CERTIFICATE OF APPROPRIATENESS

Property: 531 Harvard St, Lot 5, Block 290, Houston Heights Subdivision. The property includes a historic 1,872 square foot, two-story wood frame single-family residence and a detached garage situated on a 6,600 square foot (50' x 132') interior lot.

Proposal: Alteration – Windows

NORTH SIDE ELEVATION*

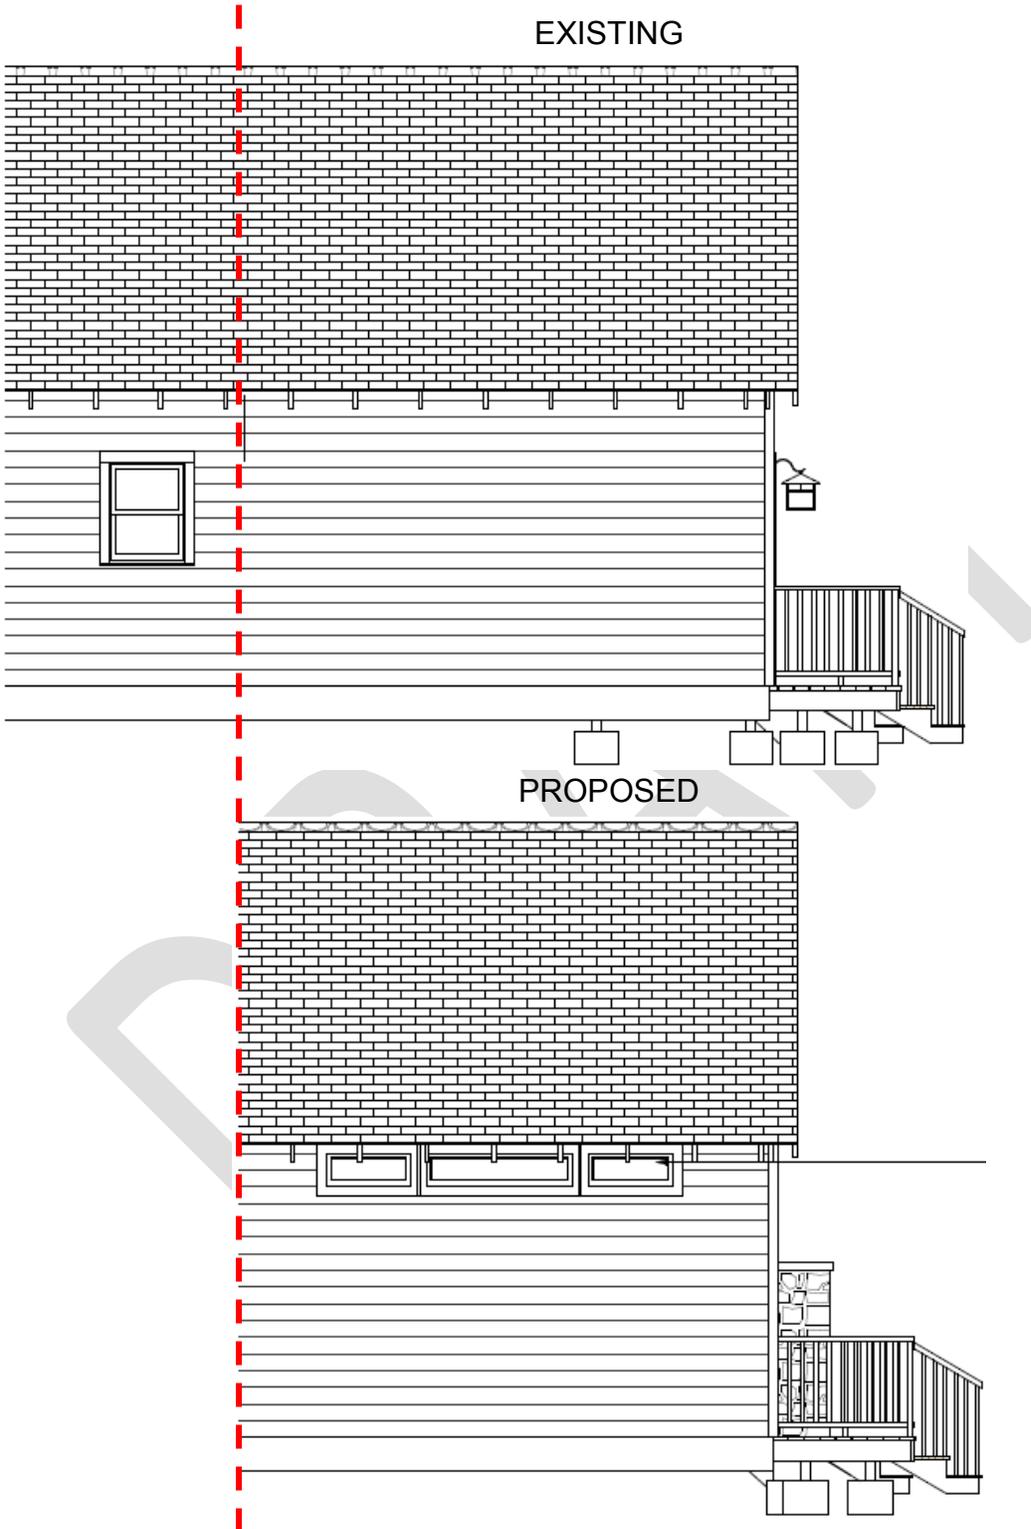
Side Elevation: Three fixed wood windows will be installed on the north elevation of a ca. 2005 addition. Two
(North) windows will measure 30" x 12" and one window will measure 52" x 12".

Recommendation: Approval

SOUTH SIDE ELEVATION*

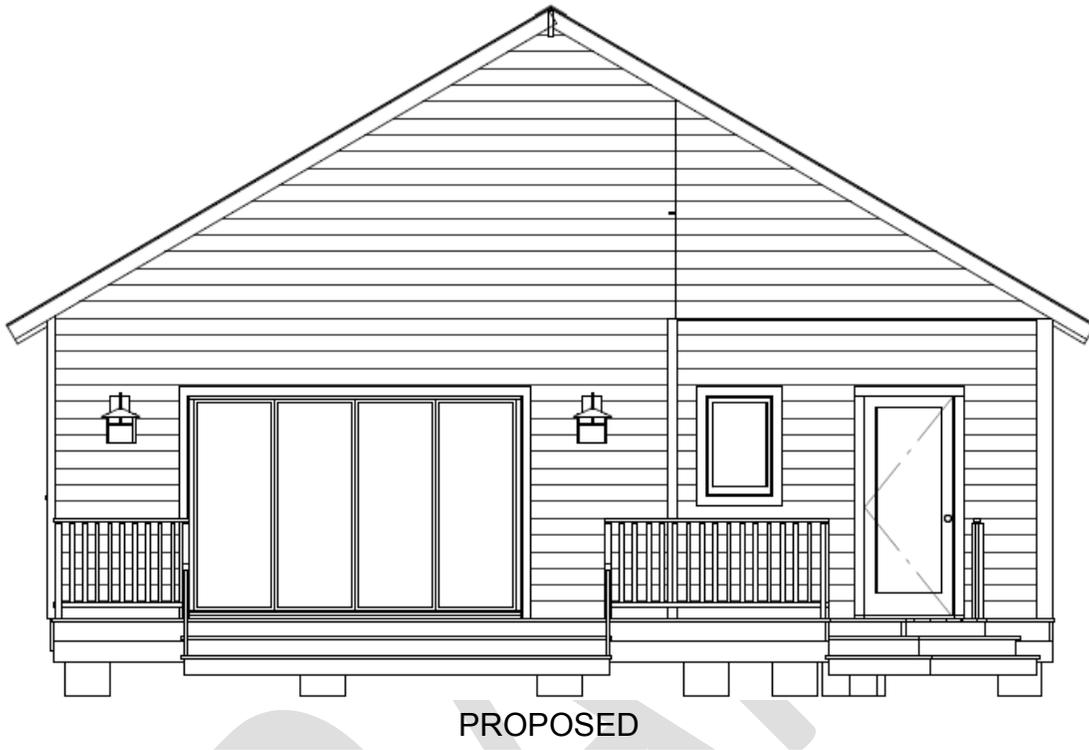
Side Elevation: The alteration to the south side elevation is obscured by the existing structure.
(South)

WEST (REAR) ELEVATION

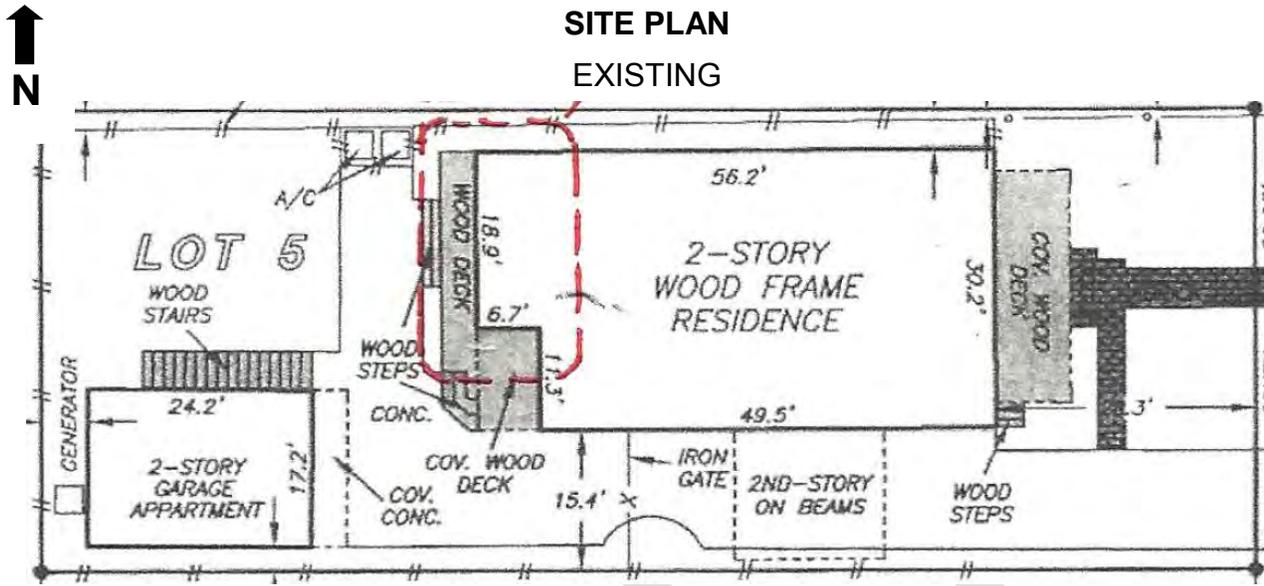
Rear Elevation: The majority of the alterations are taking place on the rear elevation, which is not visible from the
(West) public right of way.
